**COLORADO**  
Department of Transportation

**DATE:** May 29, 2019  
**TO:** Members of the CDOT/CCA Specifications Committee  
**FROM:** Shawn Yu, Standards and Specifications Unit Manager  
**SUBJECT:** June 6, 2019 Specifications Committee Meeting Agenda

# Spec Committee – June 6, 2019

### SPECIFICATION CHANGES UNDER REVIEW

# CROSS STITCHING DETAILS

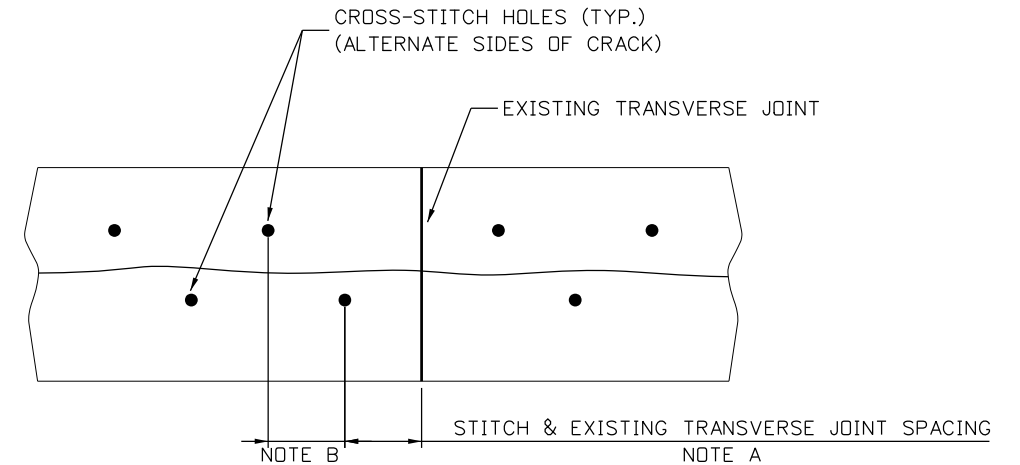
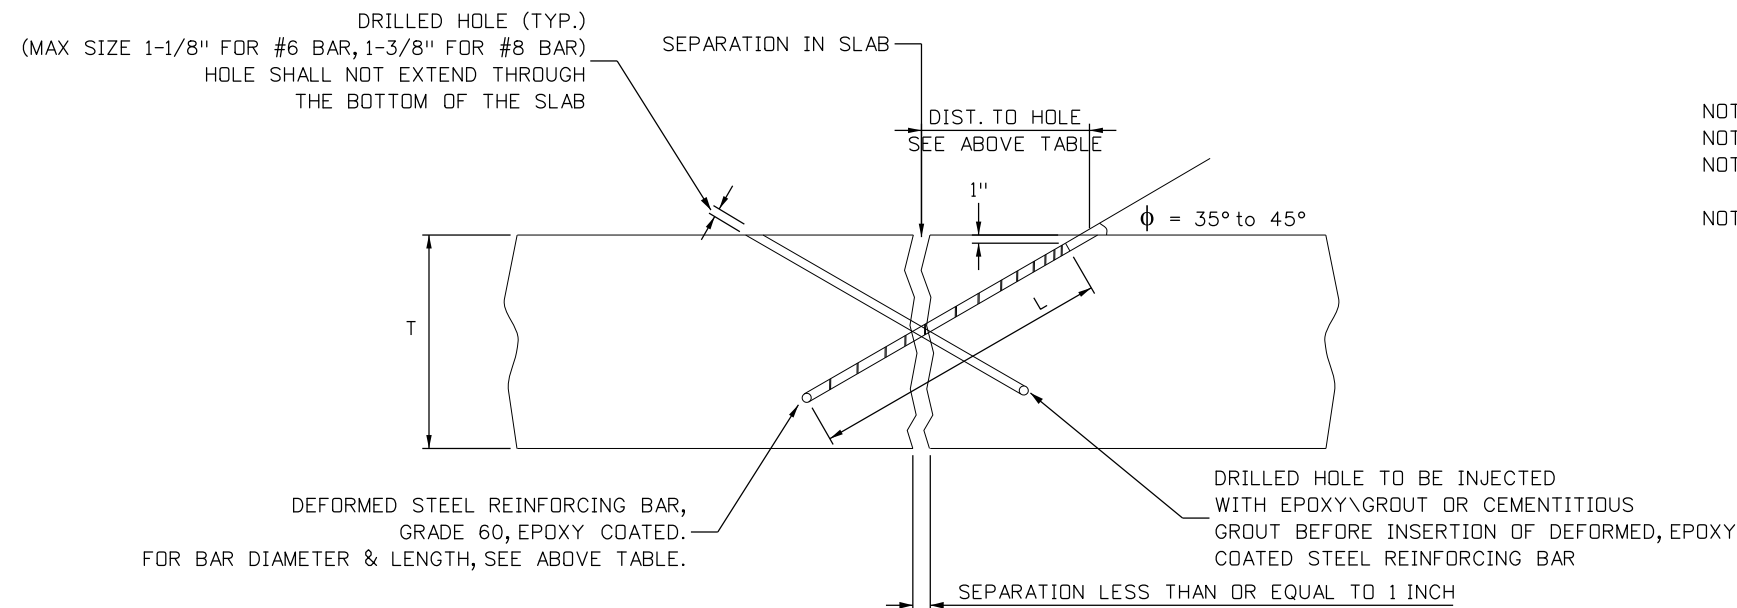
This work consists of cross stitching longitudinal cracks and joints by directionally drilling holes in concrete pavement, injecting grout, and inserting deformed steel reinforcing bars in accordance with these specifications and the details shown on the plans. Cross stitching shall not be used for fixing defective work on new construction or for thin concrete overlays (6 inches or less).

Directionally drilled holes shall be 1.000 to 1.125 inches diameter for #6 bars and 1.125 to 1.375 inches diameter for #8 bars, and drilled at an angle from the horizontal designated on the plans. Holes shall be started at a distance shown on the plans on a line perpendicular to the crack/joint, and shall extend through the crack/joint. Drilled holes shall be spaced on 20 inch centers and shall alternate from side to side along the full length of the crack/joint. Holes shall not be drilled within 24 inches of an existing transverse joint. Holes shall not extend through the bottom of the slab.

# DOWEL BAR RETROFIT DETAILS

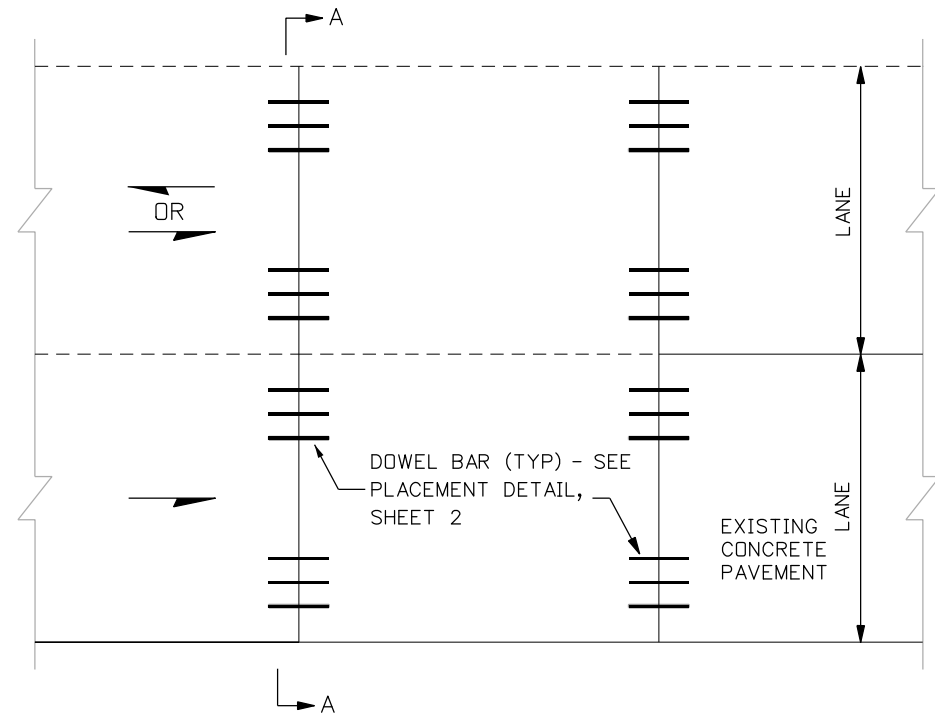
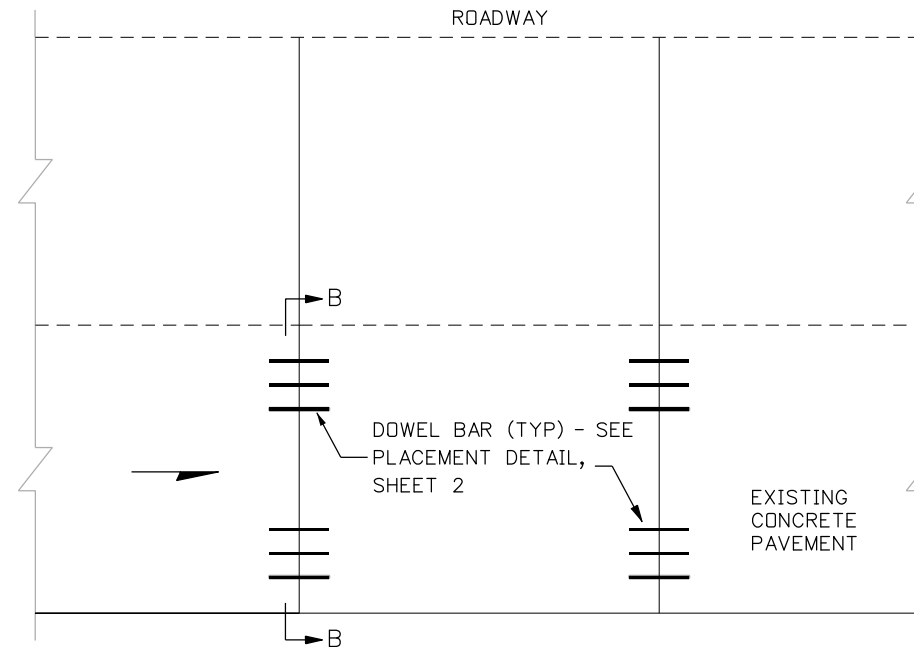
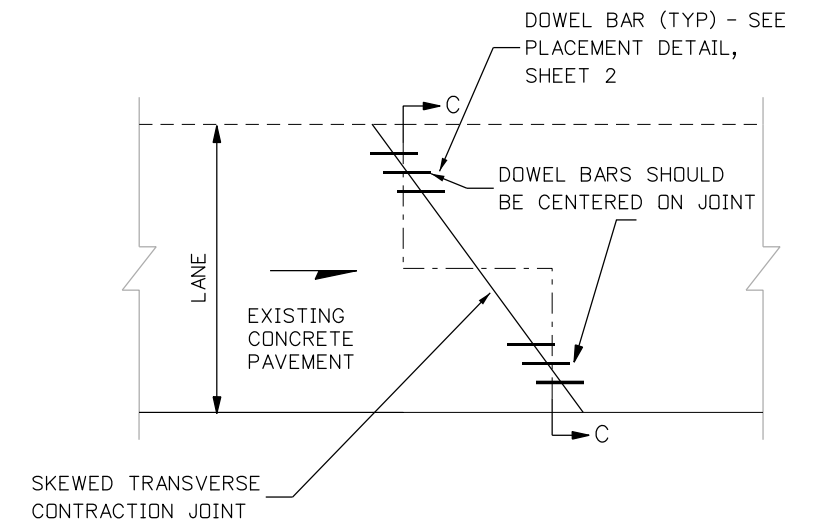
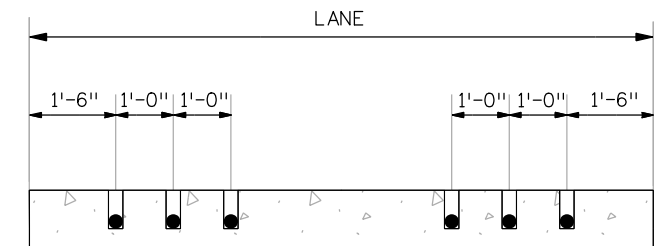
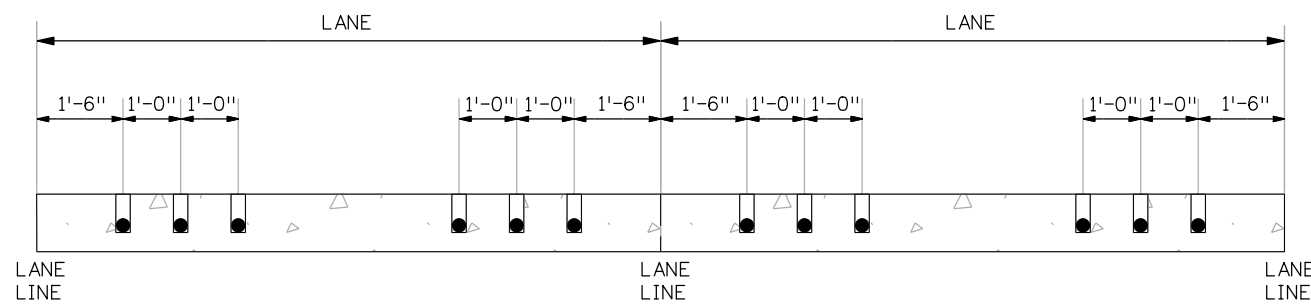
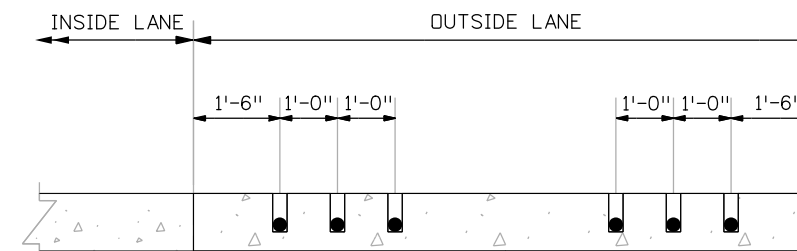
This work consists of placing epoxy coated smooth dowel bars in transverse joints as identified on the plans. This shall be done by cutting slots into the existing concrete pavement, installing dowel bars, and filling the slots at locations as shown on the plans. The surface shall be finished as approved by the Engineer. All work, including the concrete pavement slot preparation, inserting dowel bars, filling the slot with backfill material, and finishing the surface shall be performed in accordance with these specifications and the details shown on the plans.

Slots for dowel bars shall be cut perpendicular to the transverse joint as shown on the plans by using a slot cutting machine or walk-behind saw. Slots shall be of adequate length and width to accommodate the dowel bar, as shown on the plans or as directed. The concrete in the slot shall be removed by using a lightweight jackhammer weighing a maximum of 30 pounds, or hand tools, to half slab depth. All damage to the concrete slab outside of the slot shall be repaired or replaced at the Contractor's expense. Slots shall be placed at locations shown on the plans.

# DOWEL BAR RETROFIT DETAILS

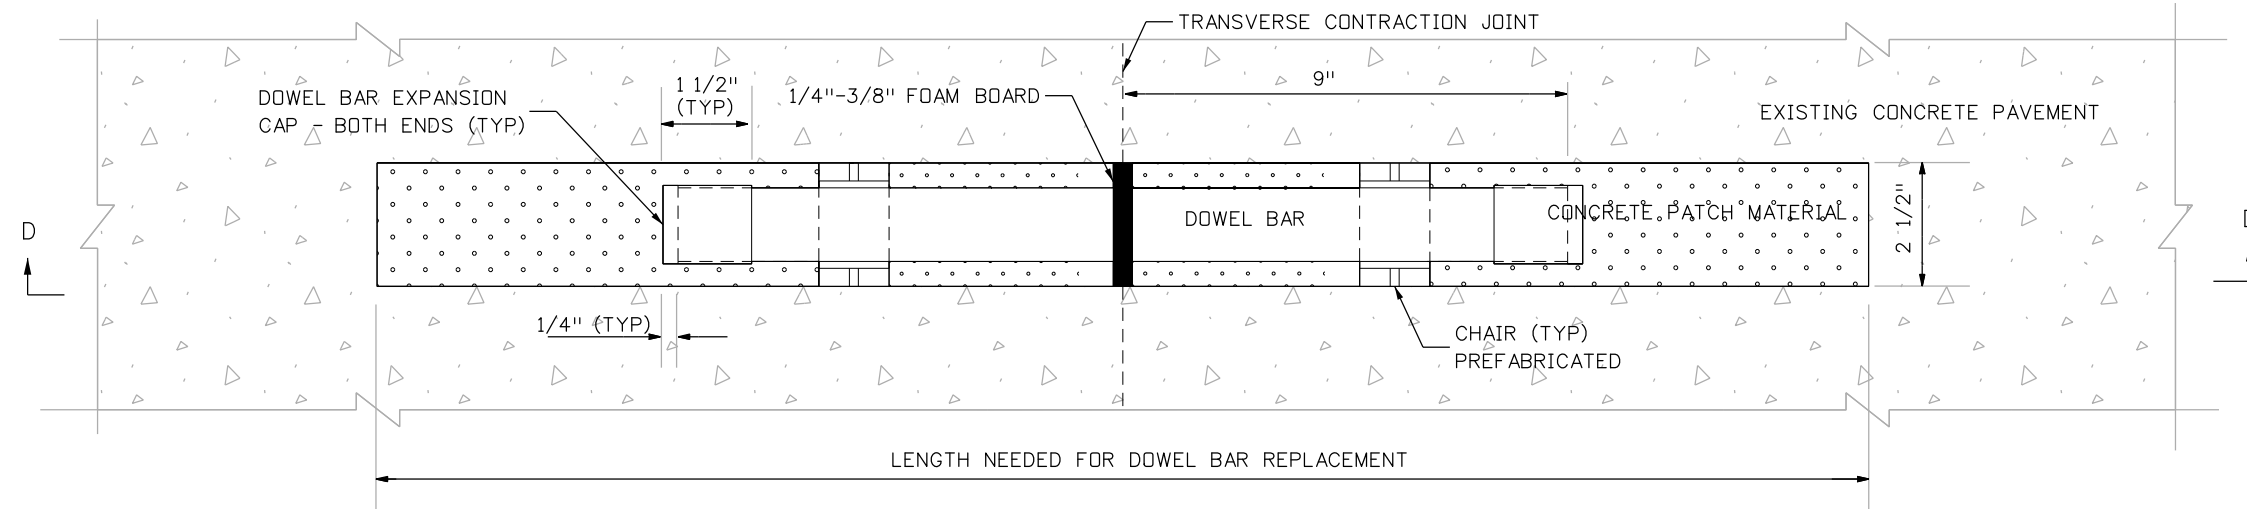
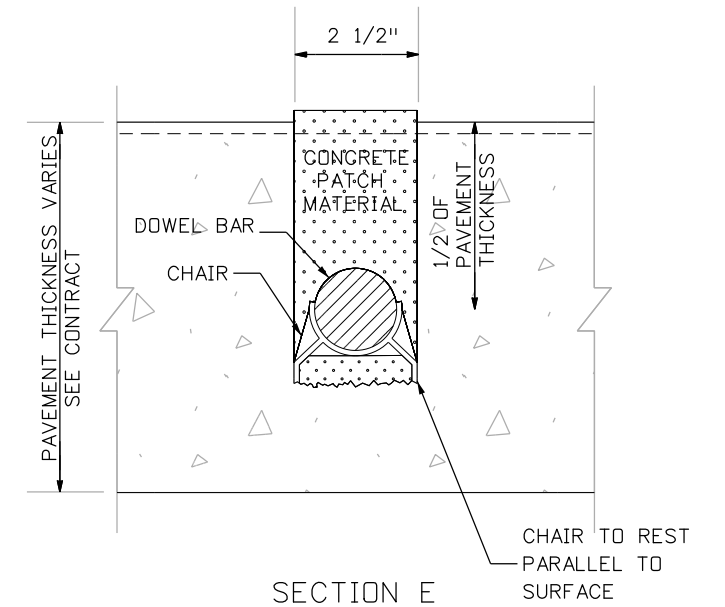
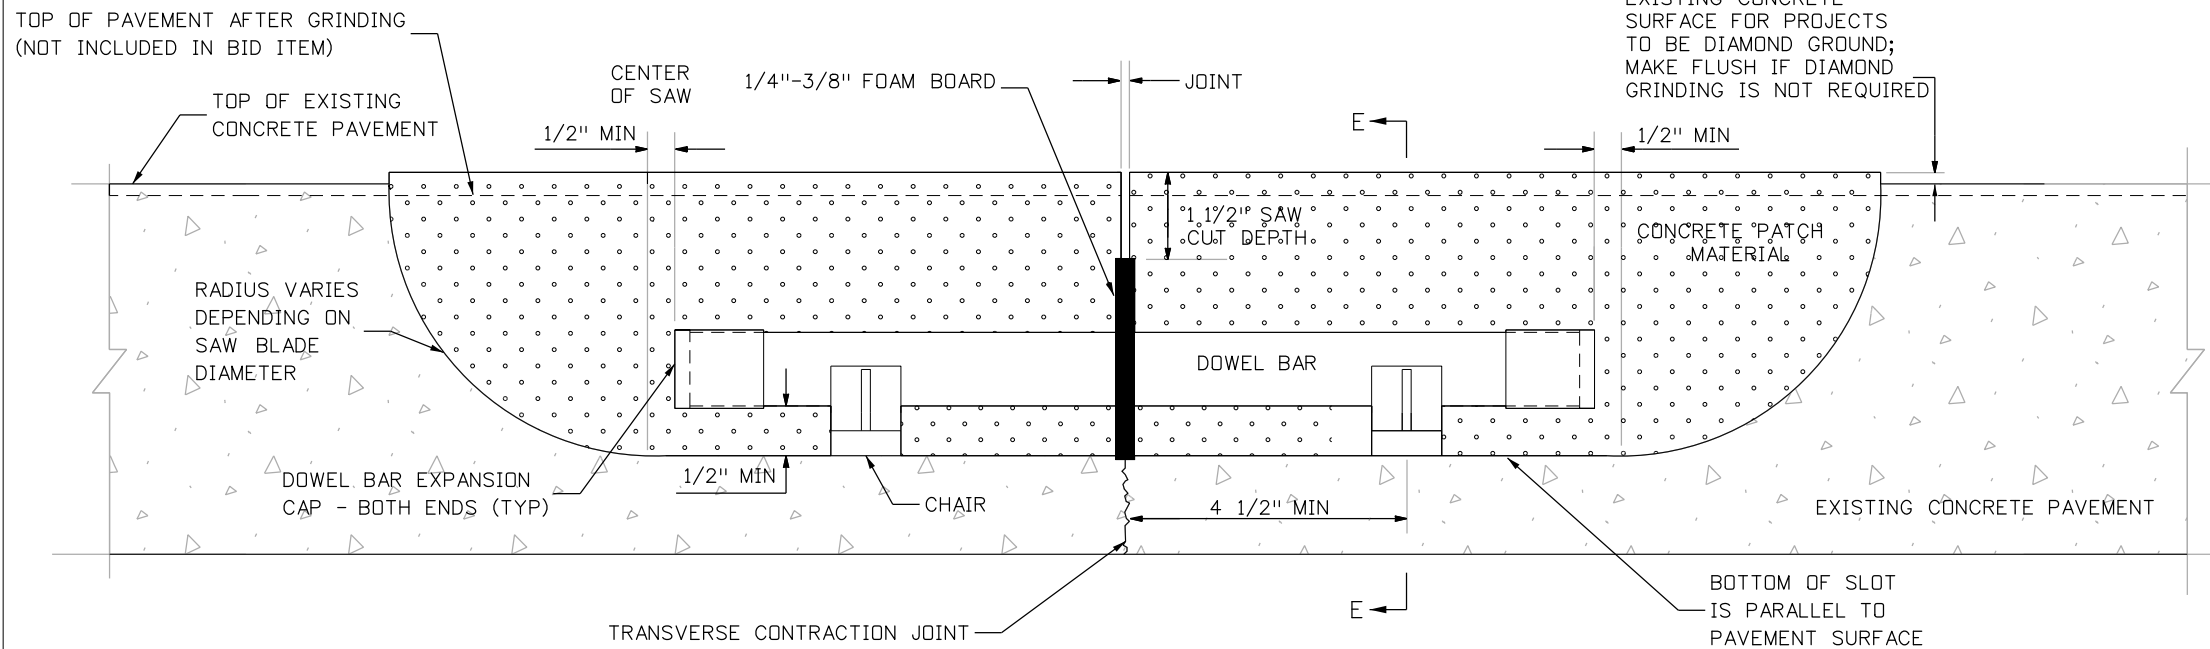
Slots shall be removed of all debris and cleaned prior to placement of dowel bars by sandblasting or other procedure so that clean aggregate is exposed. Prior to placement of backfill material, each dowel bar shall be equipped with a 1/4 to 3/8-inch thick foam core board to provide a tight seal at the joint. Dowels shall be placed on chairs so that the bar is sitting a minimum of 1/2 inch above the bottom of slot and perpendicular to the transverse joint. The chairs shall be epoxy coated steel or plastic rigid enough to hold the dowel in place during grout placement. The existing transverse joints shall be sealed with an approved joint sealant along the bottom and sides of the slot to prevent backfill material from infiltrating the joint. The joint sealant material shall be on the CDOT Approved Products list and shall be approved by the Engineer prior to use.

# SLOT STITCHING DETAILS

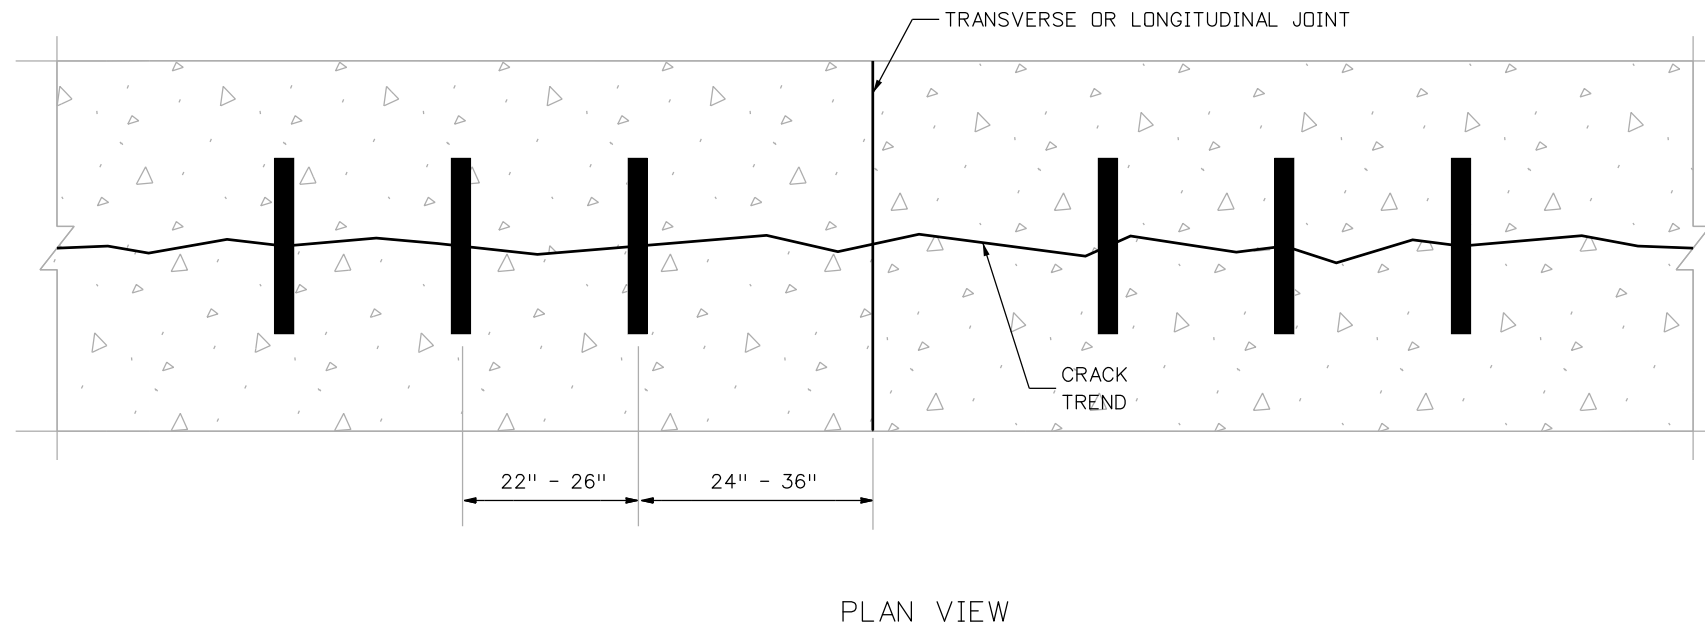
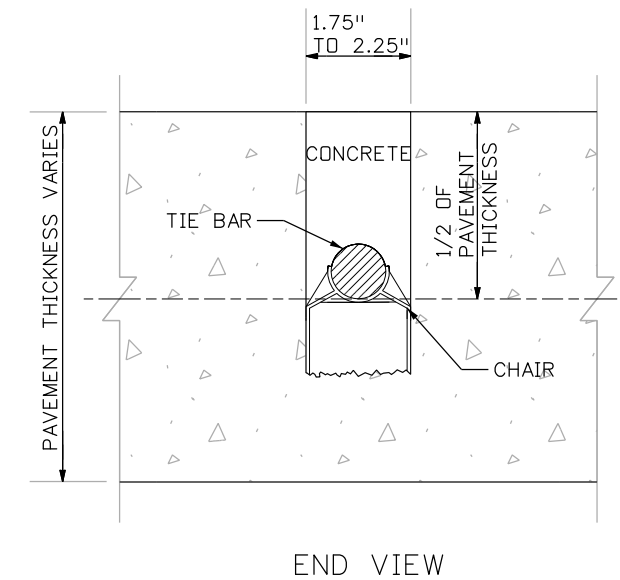
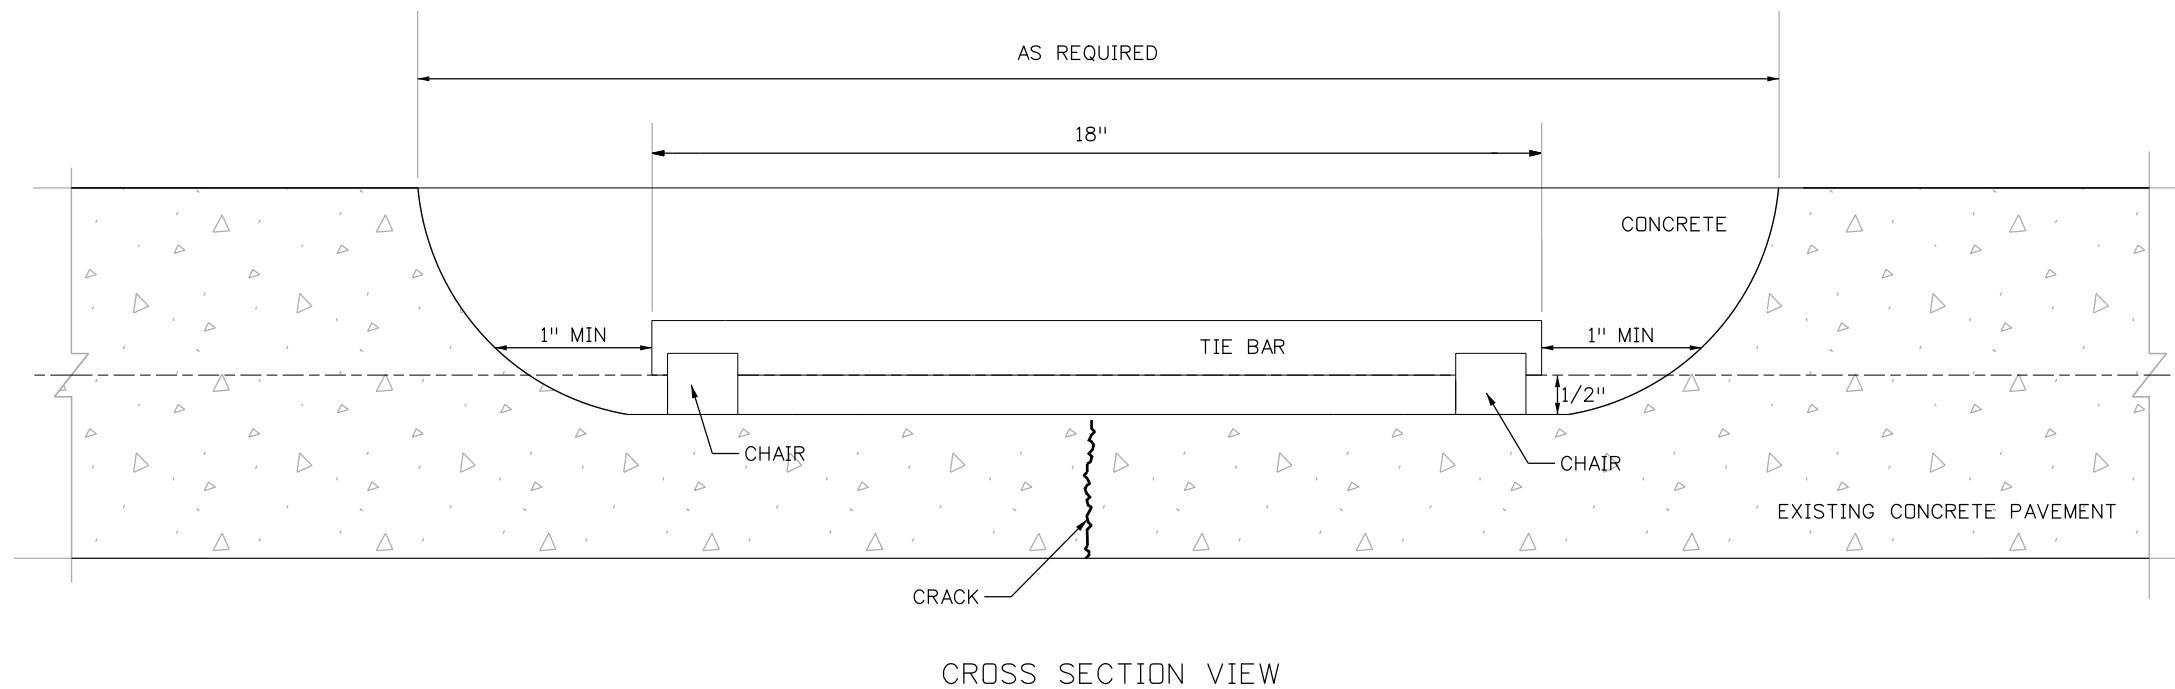
*Slot Formation.* Slots shall be made from multiple saw cuts made with a diamond impregnated saw blade to a depth as shown on the plans. Slots shall be approximately perpendicular to the general trend of the crack. Slots shall be 1.75 to 2.25 inches wide. Lightweight jackhammers weighing less than 35 pounds or hand tools shall be used to remove the "fins" formed by sawing. The length of the slot shall allow the tie bar to be placed at the mid-depth of the slab with a 1 inch space between the ends of the tie bar and the ends of the slot. Deviations from this method require a method statement detailing the means and methods for how the Contractor will perform the work.

Tie bars shall be placed on support chairs to rest horizontal at the mid-depth of the slab.
